Attachment

Meeting at Alden Research Laboratory, Inc. On January 17 and 18, 2006 to Review Application of the Caldon Checkplus Ultrasonic Flow Meter (UFM) for a Power Uprate at the Seabrook Nuclear Power Plant

Figure 1 is a generic sketch of the test facility used for the Seabrook UFM testing. Flow in the

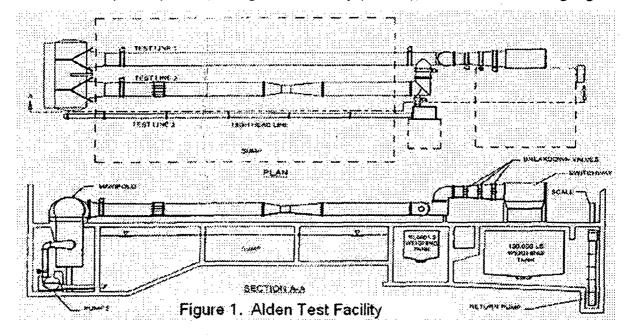
Flow from the pumps into the manifold and from the manifold into the two test sections occurs over a short path with abrupt turns. This introduces the possibility of noise, poorly developed flow profiles, and swirl in the test sections, all items of concern with UFMs but that are of lesser concern with testing other devices.

Figure 3. Seabrook Test Configuration

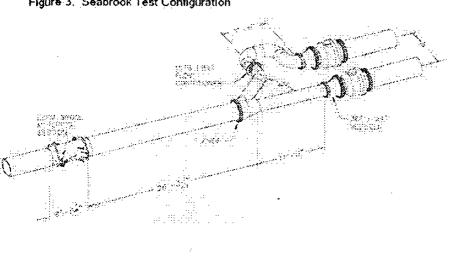
A cursory review of the configurations, data, and supporting information lead to the following preliminary conclusions:

- Seabrook's specifications for the Checkplus are 16,400,000 lbs/hr @ 447 °F (Reference D). This corresponds to close to 40,000 gpm or 20,000 gpm per feedwater train. With the exception of Test B-4 with full flow through the half-moon, the B series tests are with flow rates of roughly half what Seabrook specified for total flowrate capability. This is an open item that we are reviewing.

- 2. Water temperature during the tests was approximately 95 °F. The operational specification is 447 °F. This is an open item that we are reviewing.
- 3. Test A-1 covers the extreme condition of feedwater limited to one feedwater path. The full flow test through the half-moon covers the extreme condition of feedwater from the other feedwater path with the additional complication of introduction of swirl. These bracket the operational configurations that will be encountered during plant operation.

- 4. The tests provide Checkplus characteristics over a wide range of flow rates.
- 5. The poorest correlation in all tests requires a correction factor of 1.0048. For this case, the uncorrected Checkplus error is 0.48 percent if the test uncertainty of 0.088 percent is neglected. This close agreement between indicated and actual flow rate places less demand upon Checkplus correction than would be the case if the Checkplus was less accurate.

- 6. The Checkplus is relatively insensitive to change in flow rate over a wide range.
- 7. The Checkplus is relatively insensitive to swirl. (Some swirl is introduced at the entrance to the test sections due to the test facility. Quantitative information is expected.)

- 8. The Checkplus is relatively insensitive to changes in feedwater configuration.
- 9. There is essentially no change in Checkplus indication when two transducers are replaced. (There were only two transducers on hand during the tests. More data are to be provided that addresses transducer changes.)

As a further example, preliminary test results are provided in Figure 5 that show correction factor (that Caldon defines as MF) as a function of FR for a

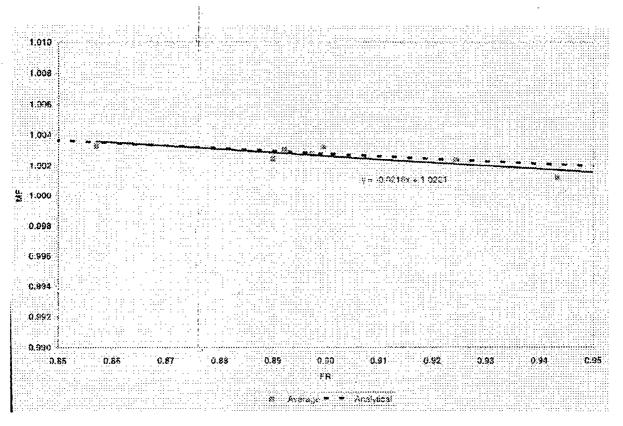
The Caldon UFM provides either four or eight average velocities as illustrated in Figure 4 for the four velocity design. Caldon then defines a "Flatness Ratio" (FR) as the sum of the center velocities (V_2 and V_3) divided by the sum of the outer velocities (V_1 and V_4) for the four path UFM, with a similar definition for the Checkplus eight path UFM. It uses this parameter to assess UFM behavior and to address characteristics under different flow conditions. With this approach, for example, Reynolds number extrapolations are no longer used.

range of conditions. Further, Caldon has also used Checkplus results to determine the influence of swirl on correction factor.
